SINGULARITY ENTERPRISES CARMEL, NY (914) 225-0699 klett@singularity.com

contact info for John Klett can be found at www.technicalaudio.com/contact.html 3m79 Technical Service Bulletin

and the later and the second second	
tiner in the	#34
	MAY, 1980
SUBJECT:	Modification of Record Logic
APPLICABLE TO:	All M79 Multi-Track Recorders
PURPOSE:	To allow Record punch-in by pressing only the Record and punch-out by pressing the Play button.
REQUIRED PARTS:	<pre>1 Ea Xstor 2N3643 83-1530-2234-4 1 Ea Diode 1N914 83-1530-0083-7 1 Ea Res 10k, 1/4w 2% 83-1520-7308-2 1 Ea Res 820ohm,1/4w,2% 83-1520-7227-4 1 Ea Standoff #4 x 3/8 83-9350-0227-5 1 Ea Screw 4-40 x 5/8 83-9260-4519-2 1 Ea Nut 4-40 83-9260-2003-9 1 Ea Washer, Lock, #4 83-9261-4203-1 2 Ea Washer, Nylon, #4 83-0822-6610-7 A/R Wire, 24AWG, Solid Perforated Vector Bd. 3/4" x 1"</pre>
PROCEDURE:	<ol> <li>Lift Transport to the raised position.</li> <li>Locate diode CR2 on the Play switch</li> </ol>
	<ol> <li>Replace CR2 with jumper wire. Refer to Composit Schematic, Figure 6-1 of manual</li> </ol>

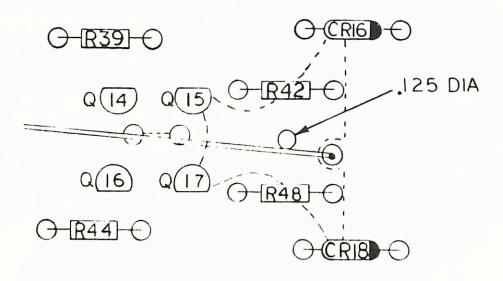
- Remove Logic and Master Bias Supply board from rear of M79.
- 12. Add the circuit shown in Figure 1, below, to the Logic board.

c. Fabricate circuit shown in Figure 1, above, on 3/4" x 1" perf board, using Figure 3, below, as a guide.

- d. Attach perf. board to Logic board, using 3/8 standoff and mounting hardware; ensuring that hardware is isolated from traces by nylon washers.
- e. Connect the 24 AWG wire from the components on the perf. board to Logic Board.

- 1. Attach wire from 10k resistor to +28v (bottom side of R44).
  - Attach wire from 820ohm resistor to gnd (top side of R48).
  - 3. Attach wire from cathode of 1N914 diode to J3-9 (lower left connector).

Fig. 1

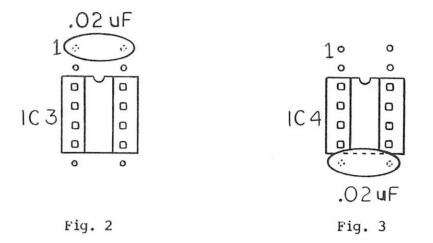
Bulletin No. Date	#31 MARCH, 1980			
SUBJECT:	Replacement of uA741 OP Amps on Signal Electronics P.C. Boards with LF356A Op Amps			
APPLICABLE TO:	All M79 Signal Electron	ics Boards		
PURPOSE:	To improve the performance characteristics of the M79 by upgrading the parameters of the Op Amps used in the Record and Monitor Amplifiers.			
		uA741	LF356A	
	Power B.W. Slew Rate Input Noise V	8kHz – Typ 0.5V/uS – Typ 25nV//Hz – Typ	4.5MHz - Typ 12V/uS - Typ 12nV//Hz - Typ	
REQUIRED PARTS:	I.C LF356A Cap02uF, 100V I.C. Socket - 8 Pin Mylar Tubing	83-0003-2012-3 83-1510-1008-5 83-1620-0290-7	2/Channel 2/Channel 2/Channel As Required	
PROCEDURE:	1. Remove IC3 and IC4	from their sockets.		
	<ol> <li>Unsolder and remove 14 pin sockets for IC3 and IC4</li> <li>Install and solder 8 pin sockets; leaving pins 1, 7, 8, 13 and 14 open. See Figure 1, below.</li> </ol>

NOTE: Pin numbers called out in steps 3-7, refer to original 14 pin IC layout.

Fig. 4

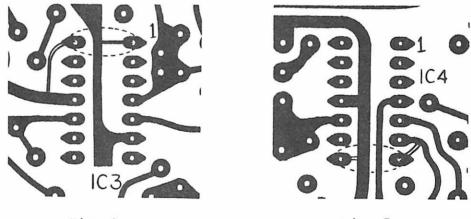
- Install one .02uF cap in vacant holes 1 and 14 of IC3. See Figure 2, below.
- 5. Install the other .02uF cap in vacant holes 7 and 8 of IC4. See Figure 3, below.

- 6. Using Mylar sleeving over cap leads; solder .02uF cap to traces from IC3 pins 6 and 11. See Figure 4, below.
- 7. Using Mylar sleeving over cap leads; solder .02uF cap to traces from IC4 pins 6 and 11. See Figure 5, below.

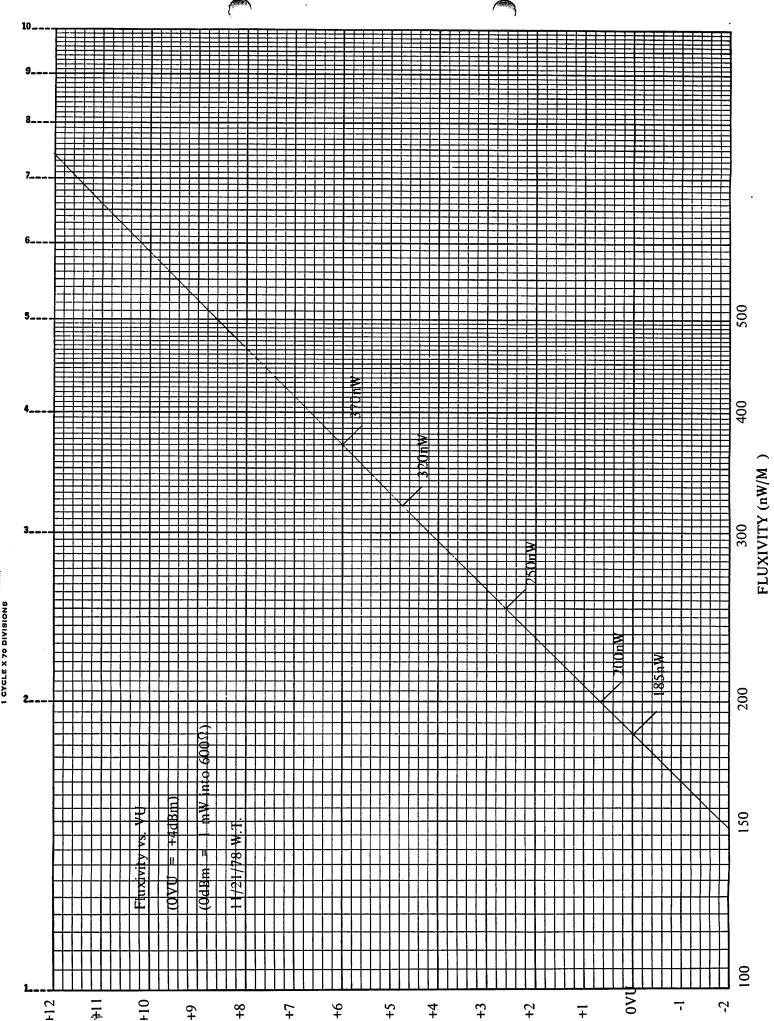
1. Determine the Fluxivity level of the Reproduce Alignment Tape and cross-reference that level to the type of Mastering tape to be used per the chart below. This resultant level (in VU) will become the Reproduce Reference level for optimum performance of the Mastering tape to be used.

STOP MUTE MODIFICATION FIGURE 1

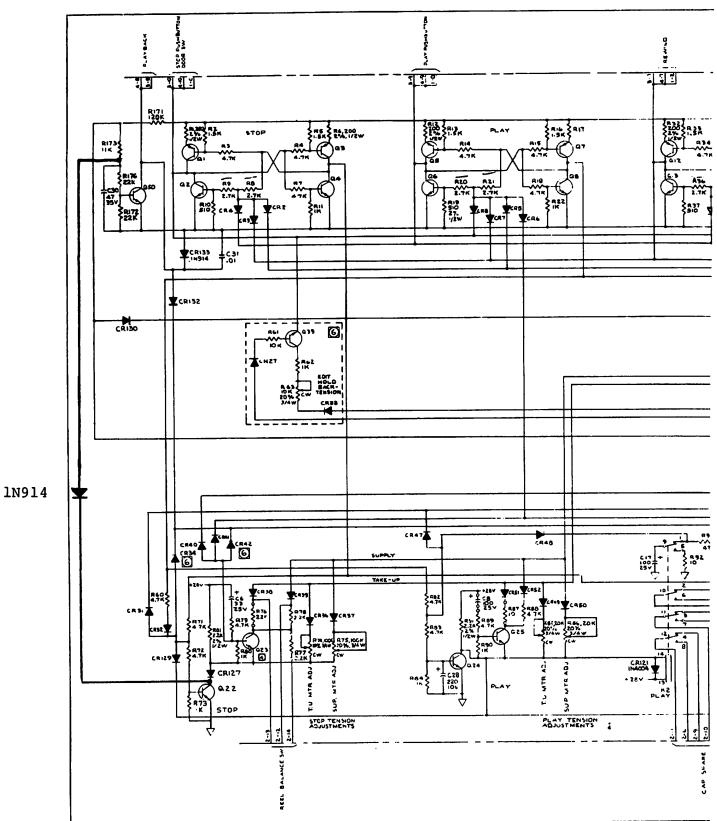
- 1) Remove logic pc Board from recorder.
- Install lN914 diode from collector of Q-22 to junction of R-173 and R-176. (cathode of diode to collector of Q-22) see Fig. 1. Use tubing on leads of diode.
- 3) Install logic pc board into recorder.
- 4) Thread a roll of tape onto the recorder which has a signal recorded on it and press stop button.
- 5) Manually move tape back and forth. Signal from tape should not be heard nor appear on meters.
- Press mute defeat switch and repeat step five. Signal should be heard and should appear on meters.
- 7) This mod will not effect the monitoring of input signals.

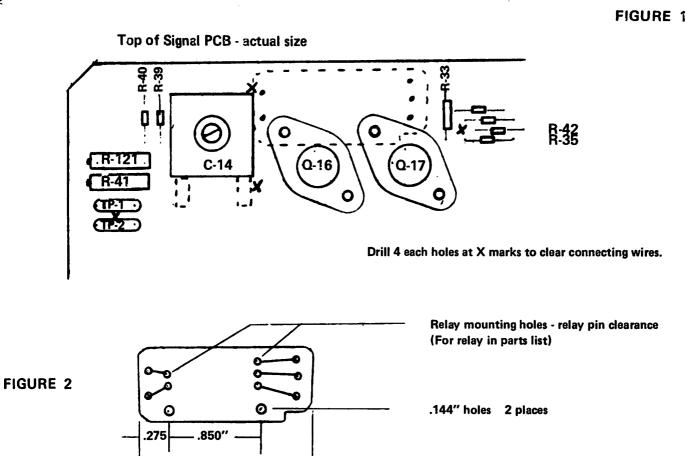
- 1. Remove Q-20, R-13, R-19, CR-9 and discard.
- 2. Remove any jumper connected to points E-10 through E-13.
- 3. Remove TP-2 (white) from board. Use care in not lifting pads from pc board (see figure 1).
- 4. R-41-A will be mounted in place of TP-2. Clip off rear lead of R-41-A. Drill a hole midway between and slightly above TP-2 mounting holes. This hole and forward most hole will be used to mount R-41-A (see figure 1).
- 5. Locate trace running from R-42 to wiper of R-41. Cut this trace about an inch from R-42.
- 6. Drill a hole behind bottom lead of C-14 (erase trimmer). Do not drill through any traces.

- 7. Locate same trace as in Step 5 and drill a hole into this trace between C-14 and Q-16 (see figure 1).
- 8. Mount relay K-A on a piece of perf board and mount the perf board to the mounting screws of Q-16 and Q-17 using two 6-32 nuts (see figures 1 and 2).

Figure 1

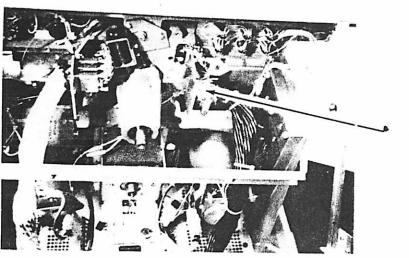
- b. Install new bracket assembly onto transport. (Figure 1)
  - c. Reconnect head connector(s). (Figure 2)
- 4. Repeat steps 2 and 3 above for bracket on record side.

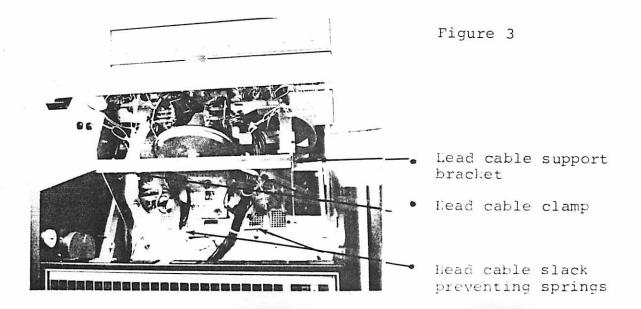
- 10. Reinstall lower belt cover.
- II. Install head cable mounting bracket 83-3320-2962 as shown (Figure 3). Use existing screw on right side, use 8-32 x 1/2" screw on left side.

- 12. Attach head cables to bracket using clamps removed in step lf. Use 10-32 hardware furnished (Figure 3).
- 13. Install a spring from each head cable bundle to rear of transport wrap around (See Figure 3).

FIGURE 1

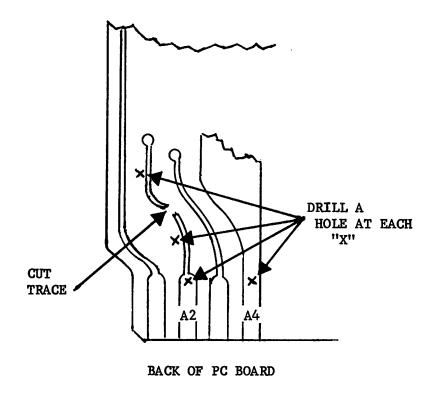
1. Drill four holes .041/.046 inches in diameter at points indicated on figure 1.

2. Cut the printed circuit trace as indicated on figure 1.

FIGURE 2

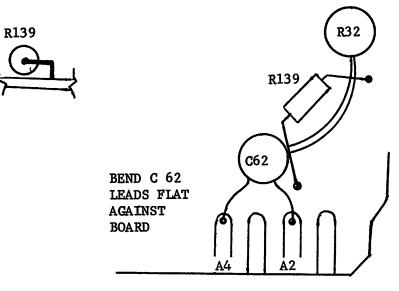
- 3. Install the capacitor, designated C-62 in the holes drilled in the finger contacts (see figure 2). Insure the leads lie flat against the board to prevent shorts to the board brace.
- 4. Install the resistor, designated Rl39, as indicated in figure 2. Bend the leads to make contact with the trace on the back of the board and solder. R-139 must be bent as shown to prevent accidental short circuits and to permit the board to be installed in the Recorder.
- 5. Change Instruction Manual schematics (see figure 3) and parts list to reflect C-62 and R-139.

FIGURE 1

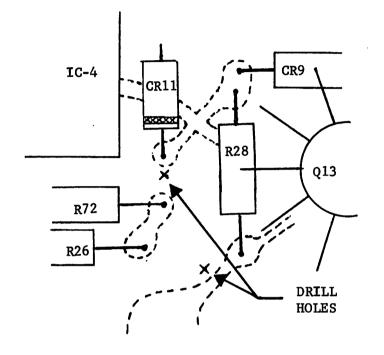
1. Drill two holes .030/.035 inches in diameter at points in figure 1.

- 2. Install the .001 $\mu$ f capacitor (designated C61) by inserting leads through new holes, bend leads to touch adjacent traces, then solder.
- 3. Check Recorder alignment and adjust if necessary.
- 4. Change Instruction Manual schematics (see figure 2) and parts list to reflect the new capacitor, C-61.

Correct Positions FIGURE 1

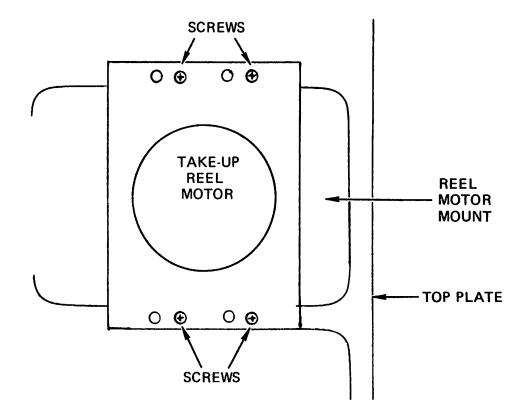
1. Raise the tape transport and observe the position of the support bracket and the stop post. If they appear as in figure 1, proceed with step 3. If they appear as in figure 2, proceed with step 2.

#### FIGURE 1

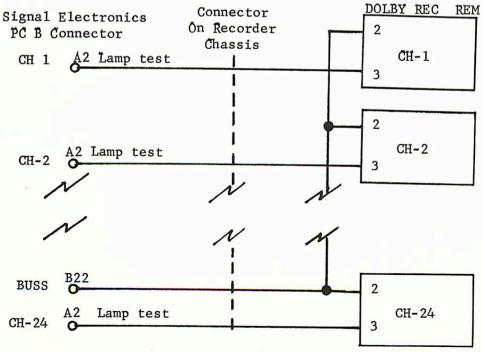
5.2	Subject:	DOLBY interface with M-79 Professional Audio Recorder
	Applicable to:	M-79 Record which interface with DOLBY M series or DOLBY A-type units.
	Purpose:	Provide remote connection of DOLBY units to M-79 recorder
	Remote connection o	of M series DOLBY units to M-79 (see figure 1).
		n A-2 of each channel signal electronics pc board to pin 3 of unit through a suitable connector on the recorder chassis.
	2. Connect pi	n B-22 bus on signal electronic pc board pin 2 of ALL DOLBY units

3. Insure R102 and R108 in CAT 44 Interface Module are 6.8 K ohms (earlier models had 2.7 K ohm or 3.3 K ohm resistors); if the resistors are not the correct values, replace them with resistors of the correct value.

#### FIGURE 2

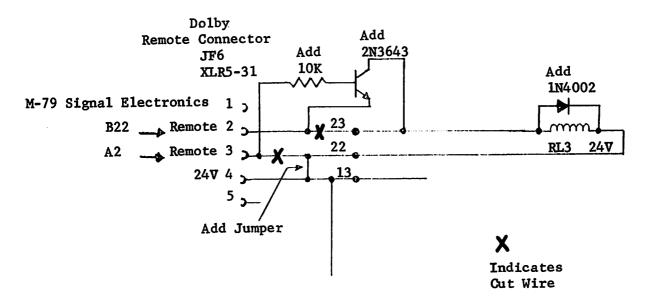
- 1. Connect Pin A2 of each M-79 Signal Electronics PC Board to Pin 3 of the DOLBY Remote Connector through a suitable connector on the recorder chassis.
- 2. Connect Pin B-22 buss on the M-79 Signal Electronics PC Boards to Pin 2 of ALL DOLBY units.
- 3. Modify DOLBY interface by adding circuit as shown in Figure 2. NOTE: Refer to DOLBY 361 Interface circuit in the DOLBY Manual.

Added Circuit may be mounted on a Vector Board inside the DOLBY unit.

FIGURE 2

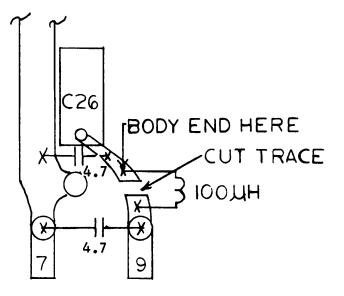
- VI. Install 4.7uf capacitor between holes drilled at top of contacts 7 & 9. (See Figure 2)
- VII. Install 4.7uf capacitor between holes drilled just below and to the left and right of C-26. (See Figure #2)
- VIII. Install 100 $\mu$ h coil in two remaining holes (See Figure 2)

FIGURE 2

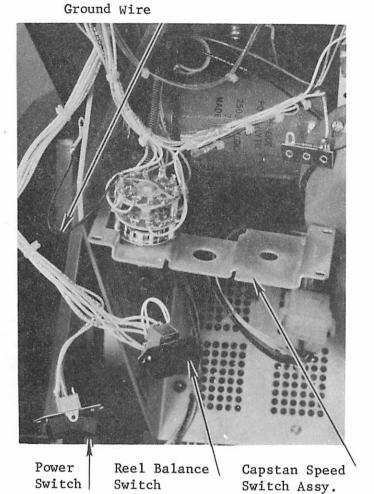
- 6) Mount Amber Lamp and 2.5 K ohm Variable Resistor. See Figure 2
- Remove Ty-raps that secure wires with the Amp Connectors and connect to Amber Lamp. See Figure 2 and 3.

FIGURE 1

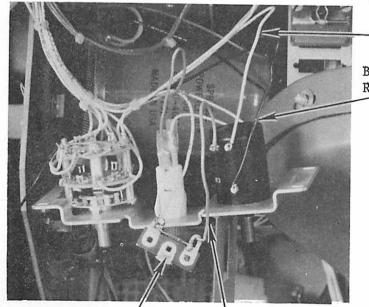
- 5) Remove the four Phillips Screws that hold the Capstan Speed Switch Assembly to the deck. This allows the Switch Assembly to drop back far enough to replace the Stripper plate. See Figure 1.
